**FARMINGTON CITY  
PLANNING COMMISSION**

## PLANNING COMMISSION MEETING NOTICE AND AGENDA Thursday October 03, 2024

# Farmington City Planning Commission Staff Report October 3, 2024

**LYON MEADOWS SUBDIVISION - PUD**

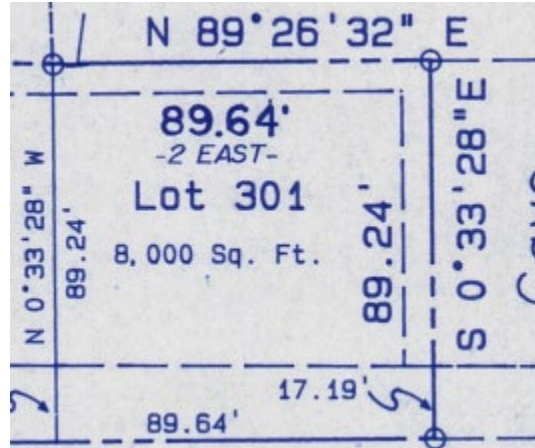
The applicant has requested the consideration of the zone text amendment because they are in the process of obtaining a building permit for a deck. The proposed deck is approximately 10 feet wide and at its closest point, about 20 feet from the rear property line. This does not meet the required rear setback of 30 feet in the R (Residential) zone. One possible solution Staff looks at for such situations is rear yard averaging, however the ordinance states that it may only be used on "non-rectangular" lots. The Thompson's lot is perfectly rectangular:

Therefore, we could not apply the average rear setback to their proposed deck site plan.

Staff's recommendation, at the request of the applicant, is to amend the text to the following:

D. Rear Yard Averaging In Residential: The zoning administrator may approve a variation in the required rear yard on residential lots ~~that are not rectangular~~ as follows: The average distance between the main structure and rear property line (measured from the rear corners of the main structure) shall be equal to the required rear yard (setback) in the zone in which the main structure is located, except that the distance measured at either corner shall not be less than twenty feet (20').

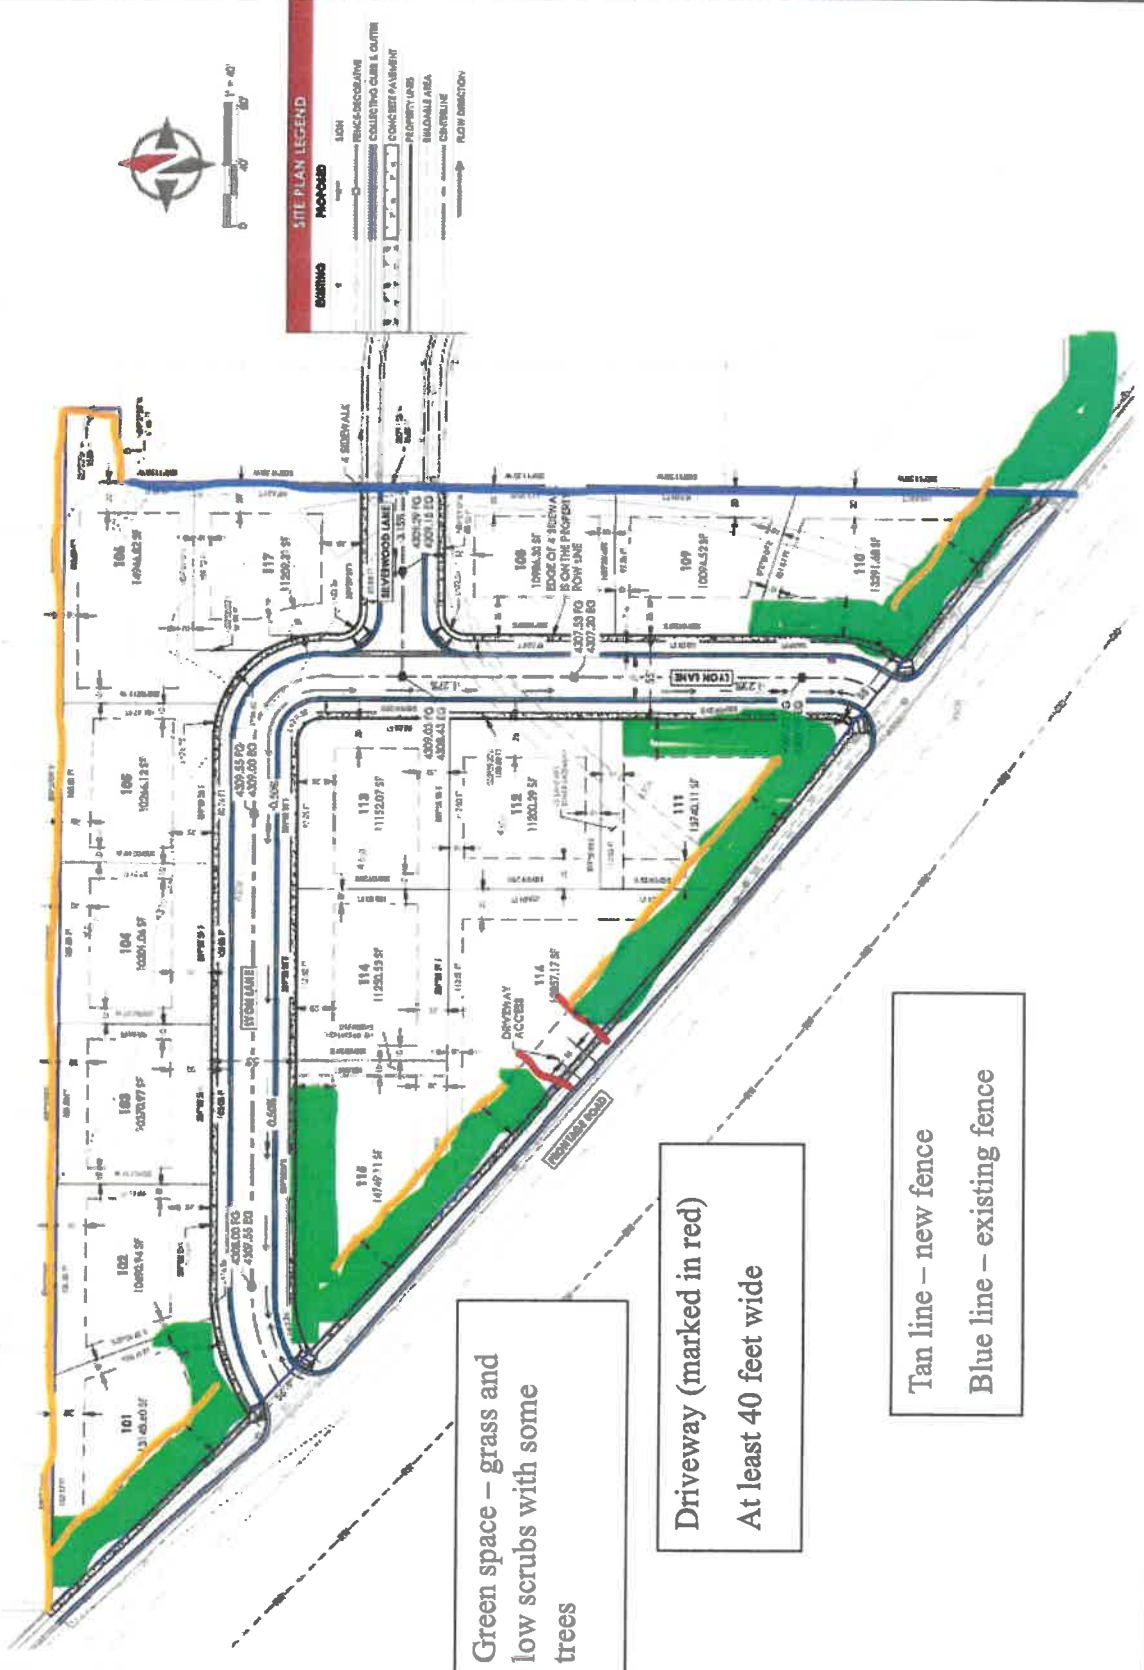
I attach a copy of their plat map with some of my comments noted there. Specifically, I am concerned about the following:

1. The Frontage Road will get increased traffic once the Shepherd Lane on and off ramp is completed. Much of that traffic will be those people in Kaysville North of the proposed Lyon Subdivision who currently access the Freeway by way of the 200 North onramp in Kaysville. That increased traffic will be a safety issue for those roads which enter on to the Frontage Road, particularly in the area of Shepherd Lane. To add safety, and to give a needed visual to our neighborhood, I think a green buffer zone needs to be placed along the Subdivision as its fronts the Frontage Road in a fashion similar to what the City required of the Silverwood Subdivision when it was created.

2. I question the wisdom of having an access driveway from Lot 116 directly to the Frontage Road. The Lyon Subdivision plan would add three new access points directly on to the Frontage Road. But if that driveway is allowed, then the width of the driveway together with side yards should be sufficient to give a good line of sight for those exiting that lot.

3. There should be a fence along the Frontage Road as shown in tan on the attached map. If that is not required, and instead a fence is placed along the Frontage Road directly next to the sidewalk, then there should be some requirement of maintenance of the area between the Frontage Road and such a fence. All the Planning Commission needs to do is to drive South along the Frontage Road from the Silverwood Subdivision to Shepherd Lane to see the unsightly mess between the respective fences and the Frontage Road. This area should be an embarrassment to the City.

Green space – grass and low scrubs with some trees

Driveway (marked in red)  
 At least 40 feet wide

Tan line – new fence  
 Blue line – existing fence

1. The 25-foot buffer needs to be like the frontage buffer for Silverwood.
2. The driveway into lot 116 needs to be at least 40 feet wide, with grass and/or low scrubs on each side.
3. No stormdrain off into Silverwood catch basin.
4. Because the subdivision is benefiting from existing fences – blue line – it should erect at its own expense new similar fences as shown as tan lines.
